PROPOSED TECHNICAL SPECIFICATION CHANGE

SEQUOYAH NUCLEAR PLANT UNITS 1 AND 2

(TVA-SQN-TS-89-26)

Description of Change

Figure 15.2.13-1 Variation of K_{EFF} with Core Temperature

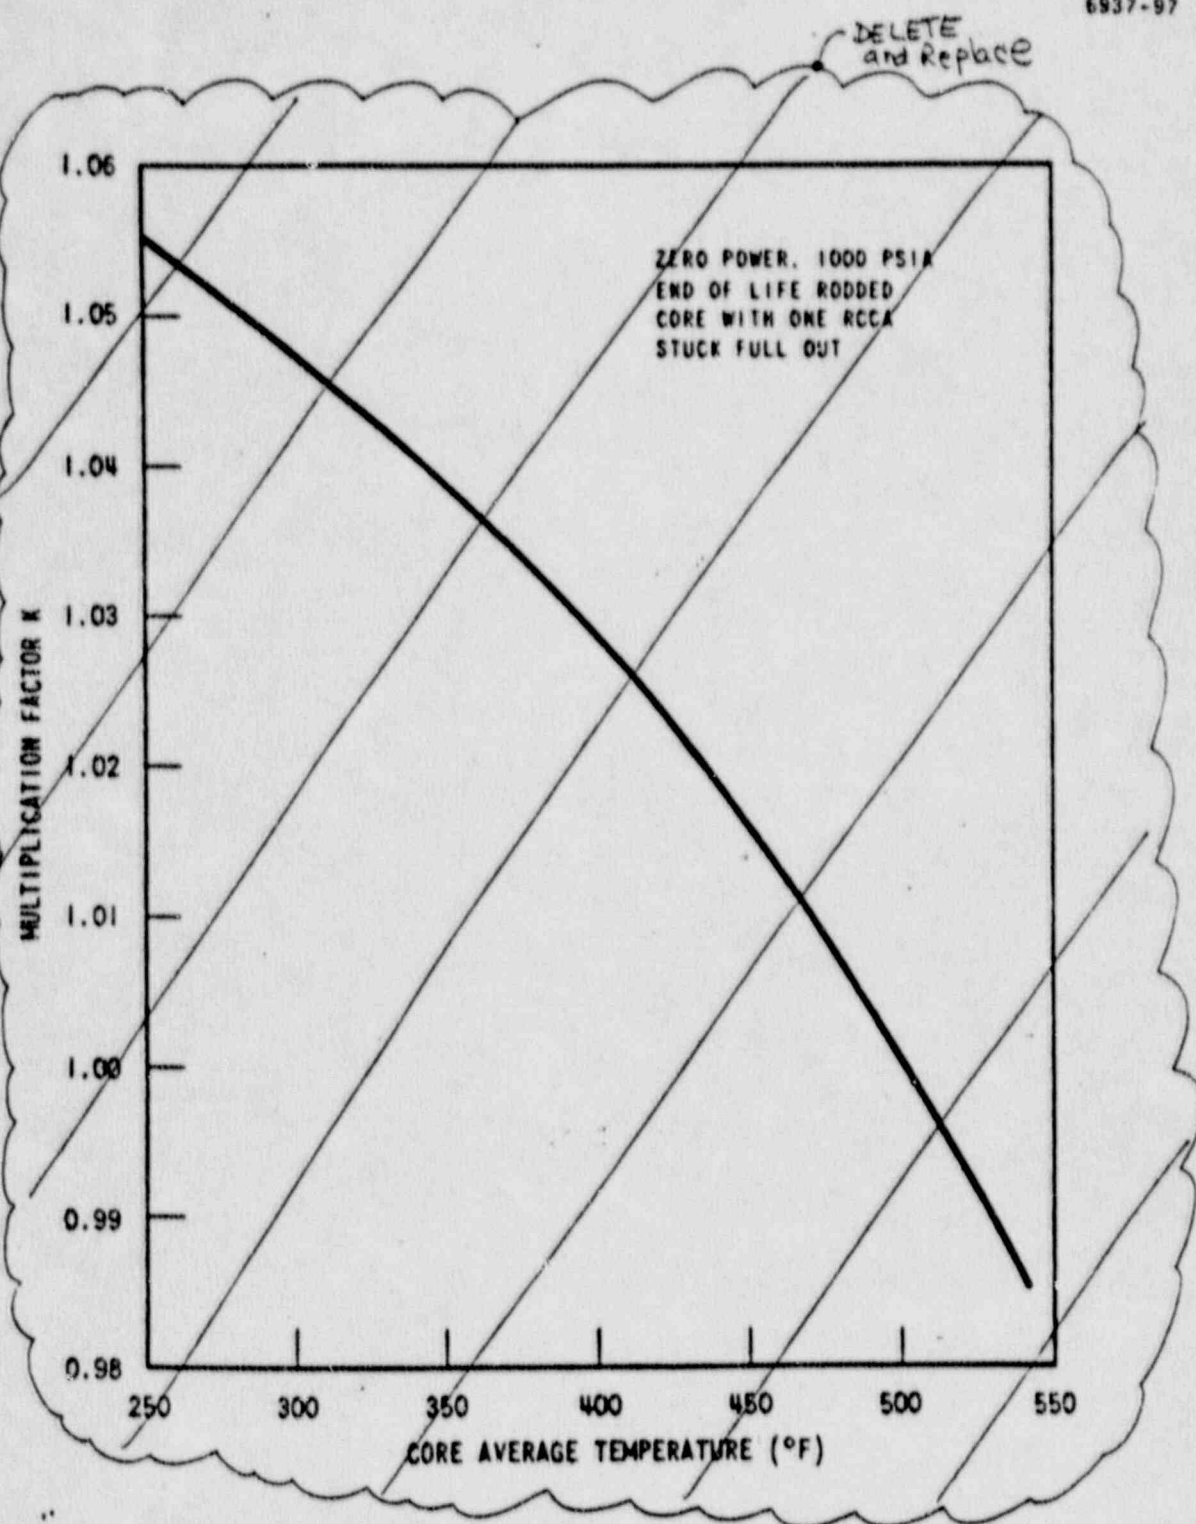
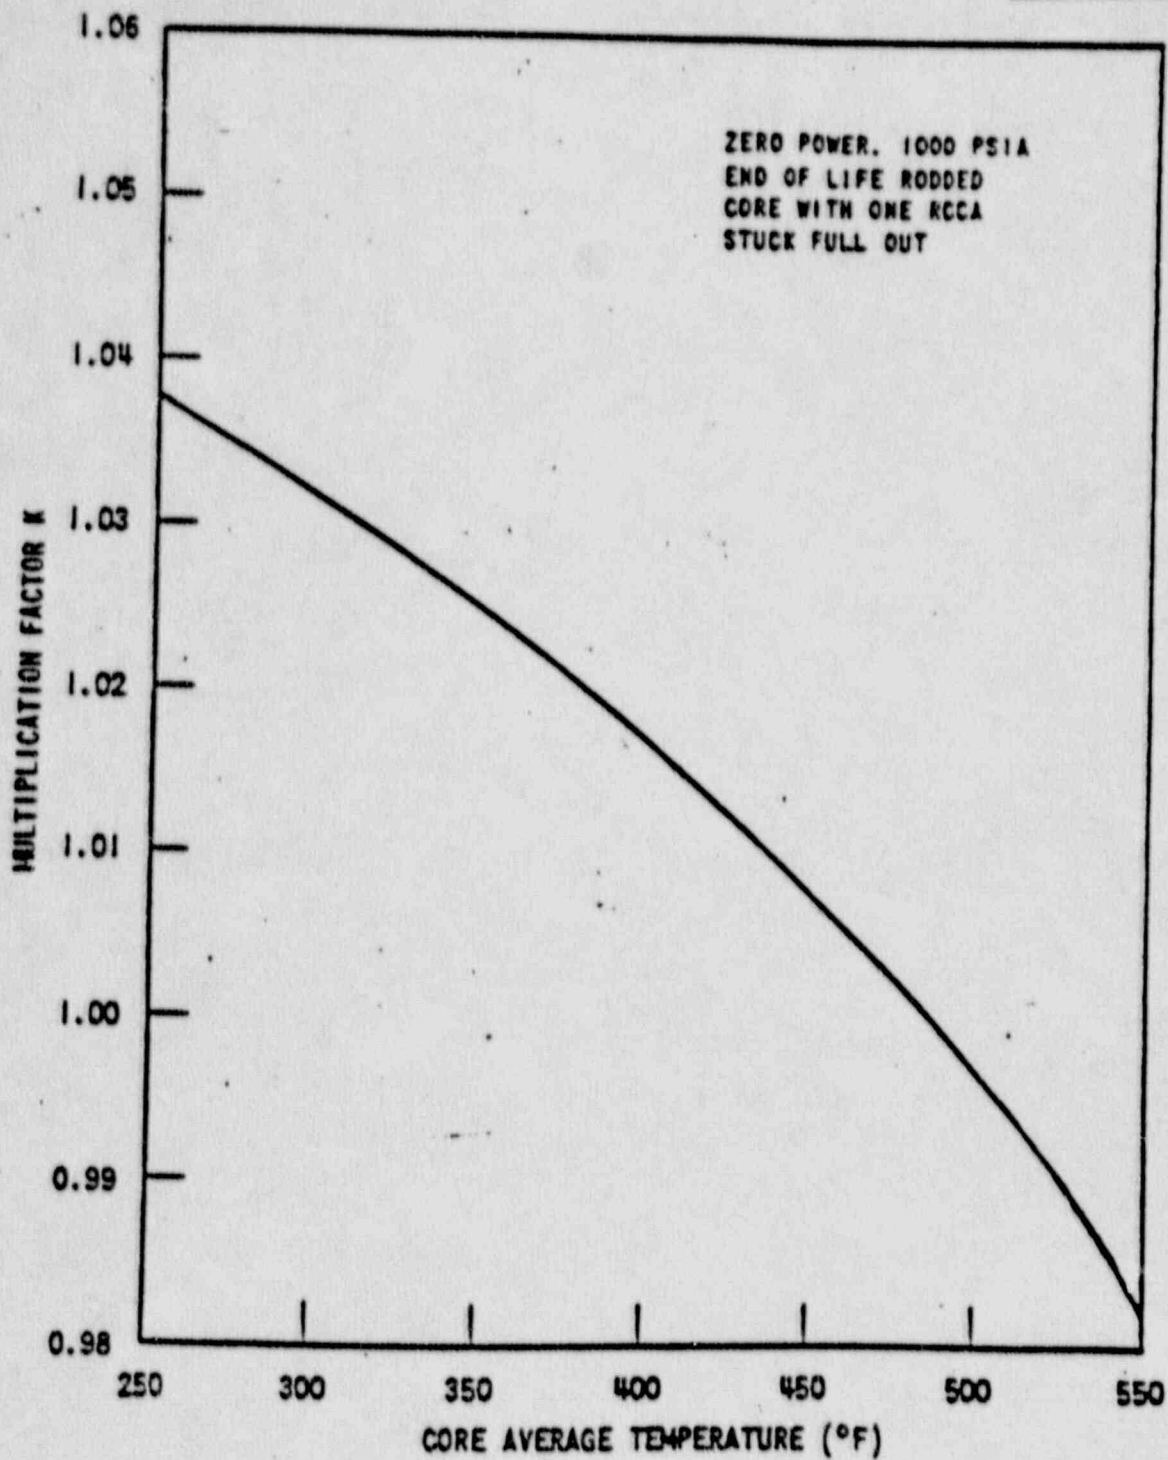
Delete
and Replace

Figure 15.2.13-2 Safety Injection Curve

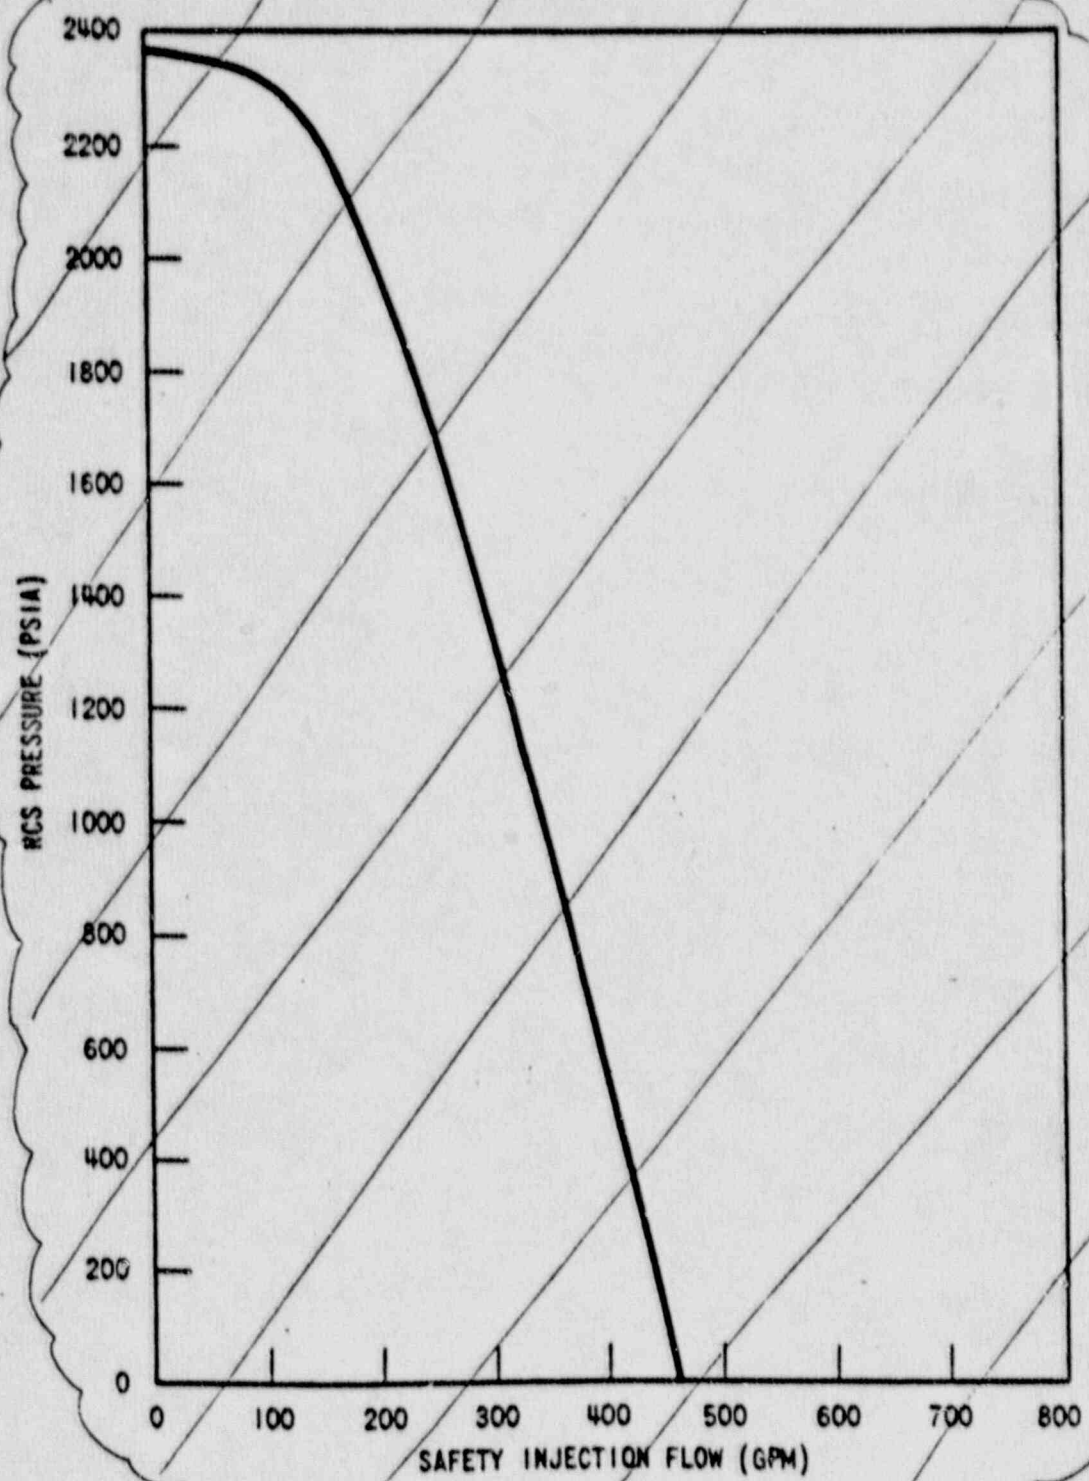
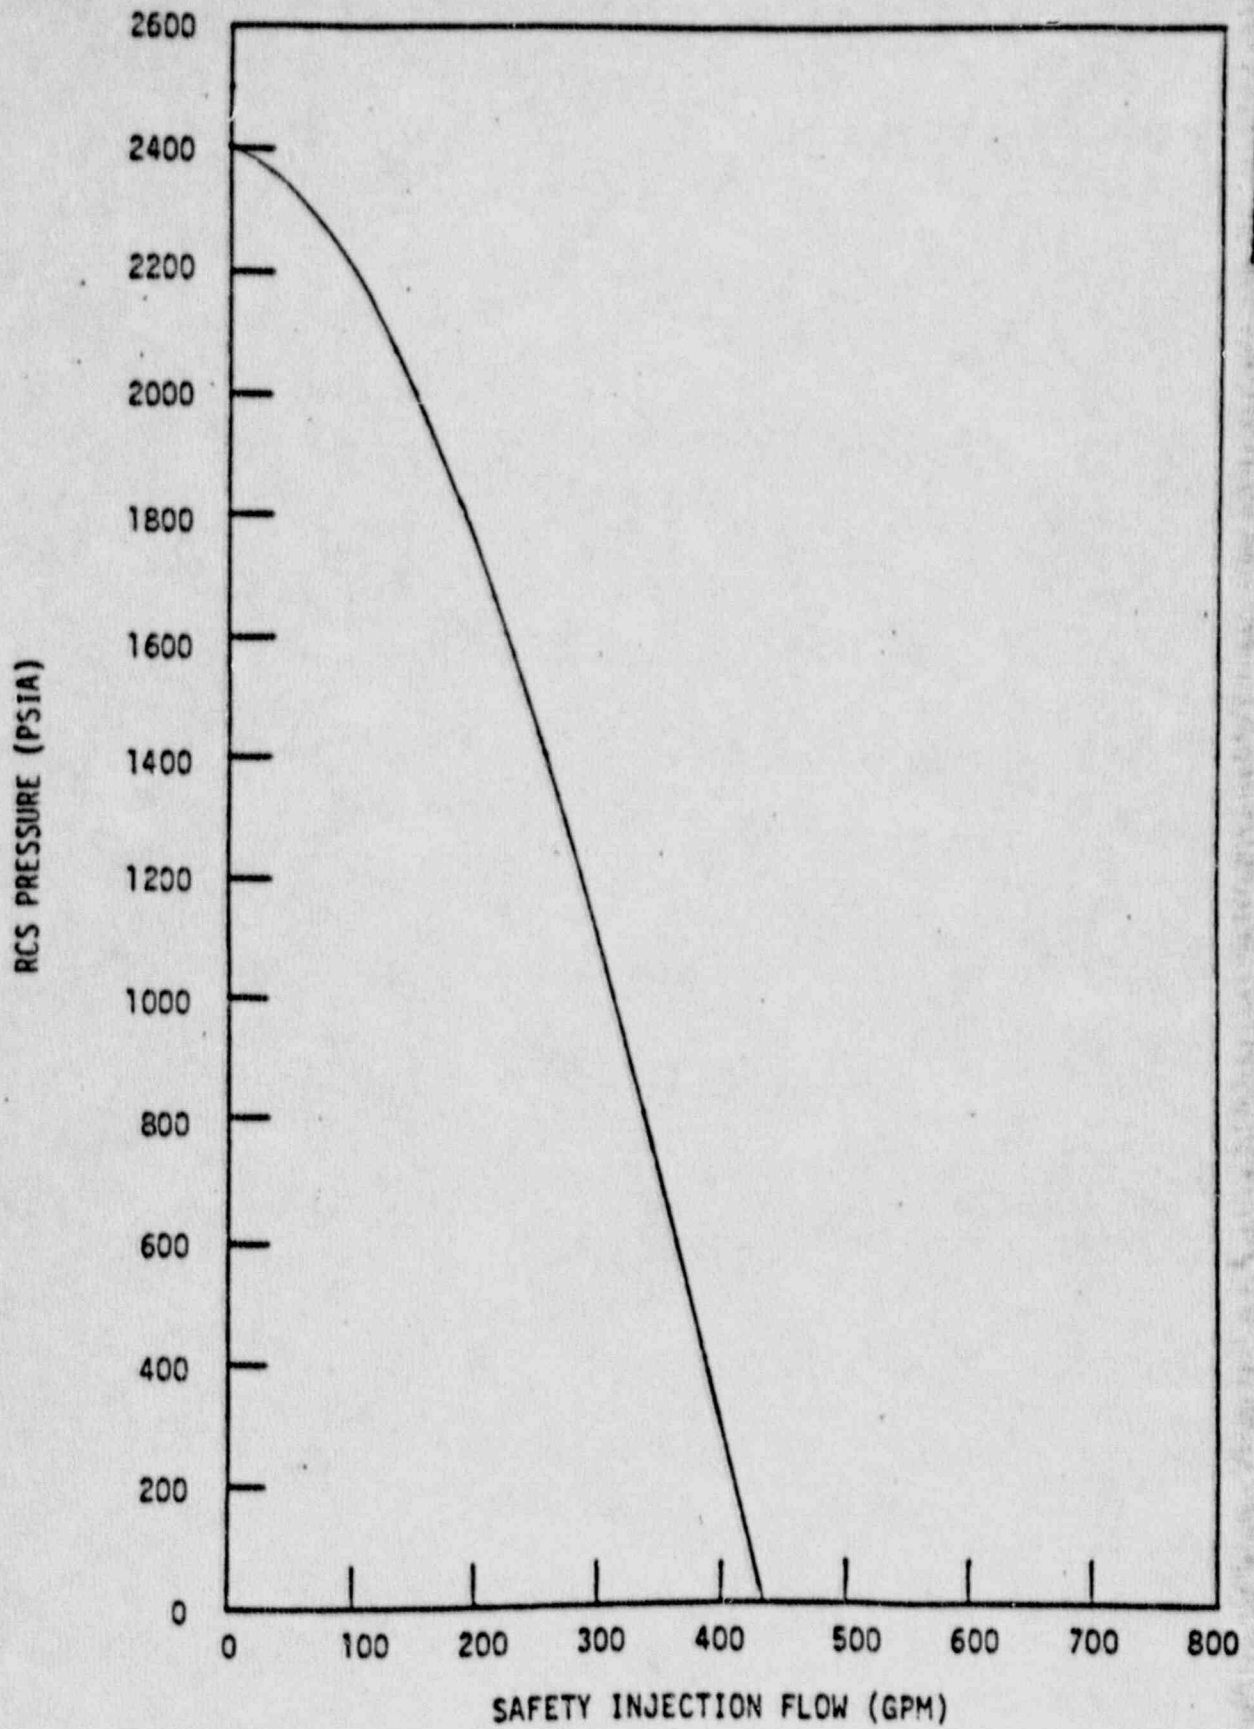
3. Minimum capability for injection of high concentration boric acid solution corresponding to the most restrictive single failure in the Safety Injection System. The injection curve assumed is shown in Figure 15.2.13-2. This corresponds to the flow delivered by one charging pump delivering its full contents to the cold leg header.

Delete
and Replace

Figure 15.2.13-3 Transient Response for a Steam Line Break Equivalent to 228 Lbs/Sec at 1015 PSIA with Outside Power Available

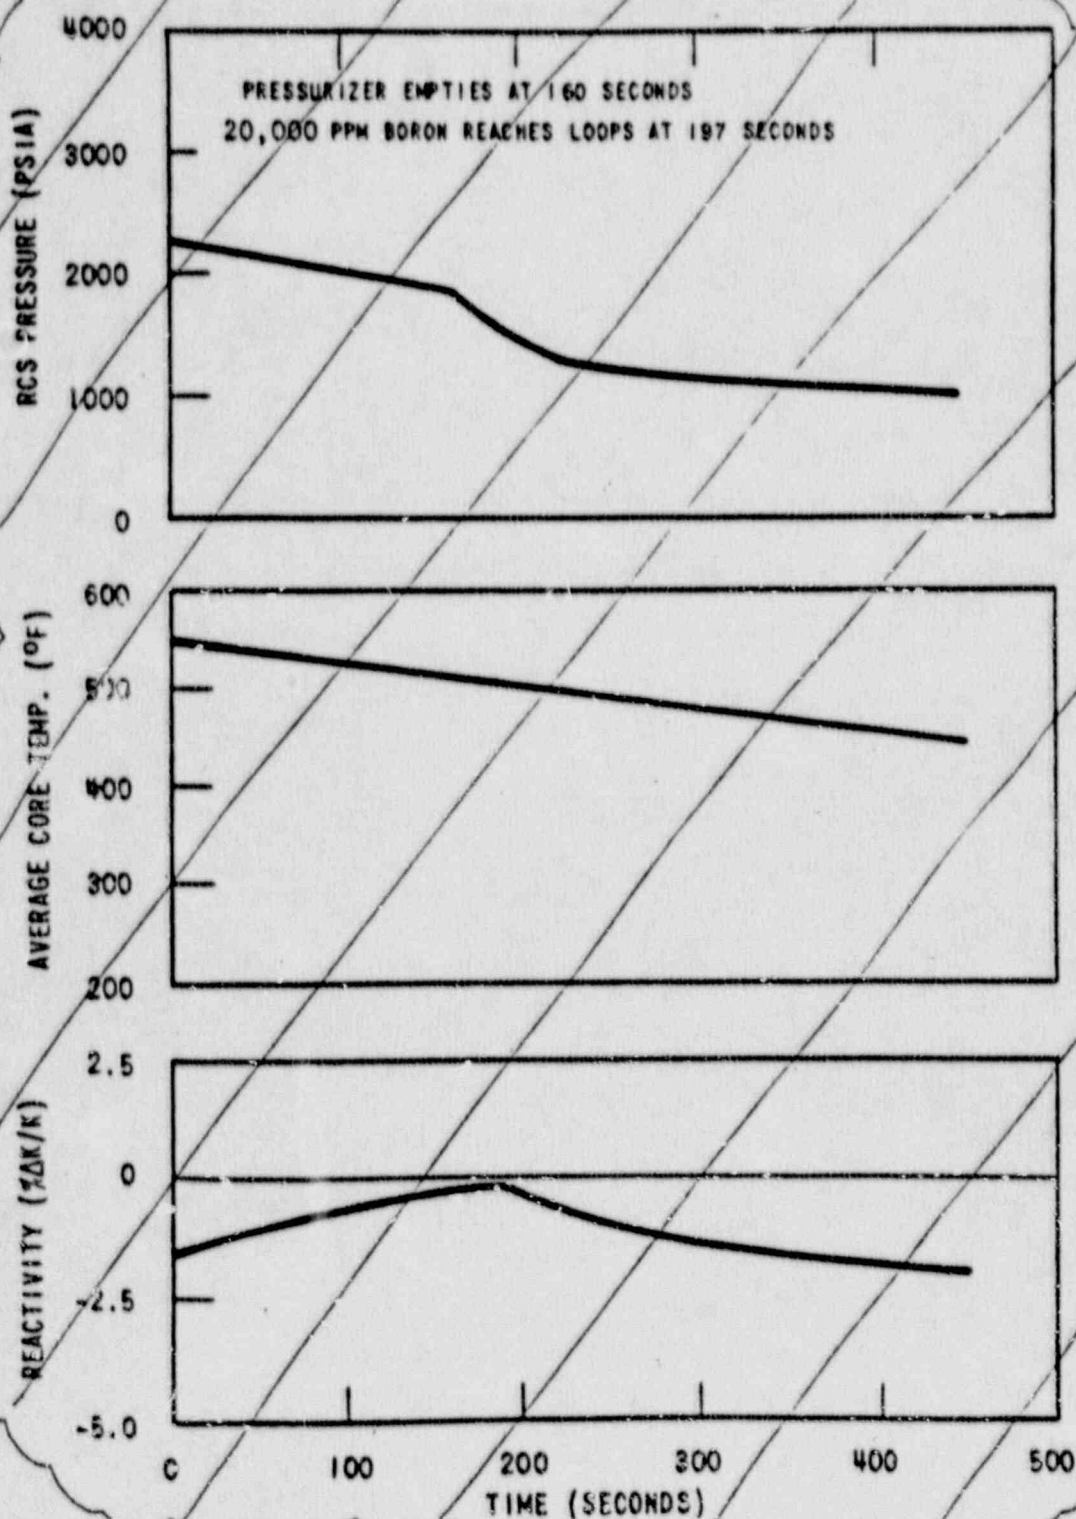
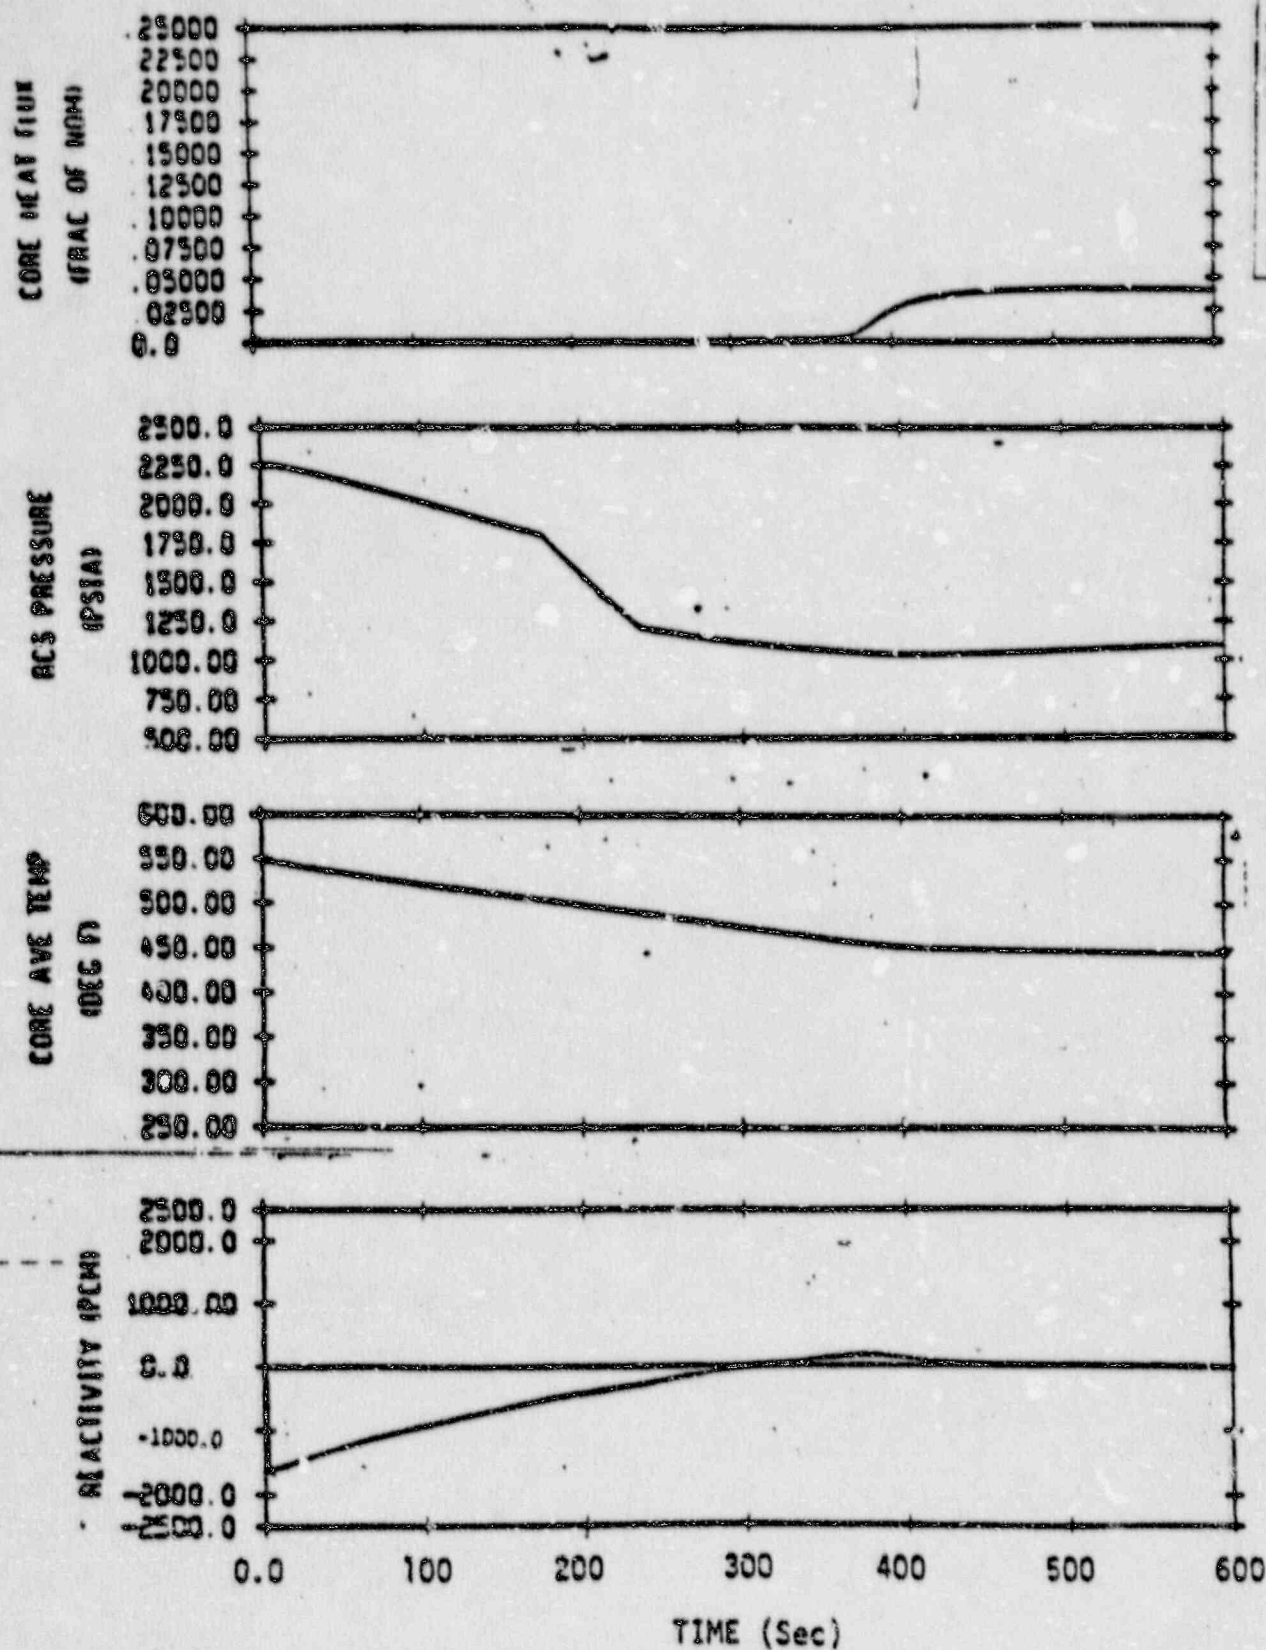
Figure 15.2.13-3 shows the transients arising as the result of a steam release having an initial steam flow of 228 lbs/second at 1015 psia with steam release from one safety valve. The assumed steam release is the maximum capacity of any single steam dump or safety valve. Safety Injection is conservatively assumed to be initiated by low pressurizer pressure although steam line differential pressure would provide a more rapid signal. Operation of only one centrifugal charging pump is considered. Boron solution at 20,000 ppm enters the RCS providing sufficient negative reactivity to maintain the reactor well below * criticality. The reactivity transient for the case shown in Figure 15.2.13-3 is more severe than that of a failed steam generator safety or relief valve which is terminated by steam line differential pressure or a failed condenser dump valve which is terminated by low pressurizer pressure and level. The transient is quite conservative with respect to cooldown, since no credit is taken for the energy stored in the system metal other than that of the fuel elements or the energy stored in the other steam generators. Since the transient occurs over a period of above five minutes, the neglected stored energy is likely to have a significant effect in slowing the cooldown. *Revise as Shown*
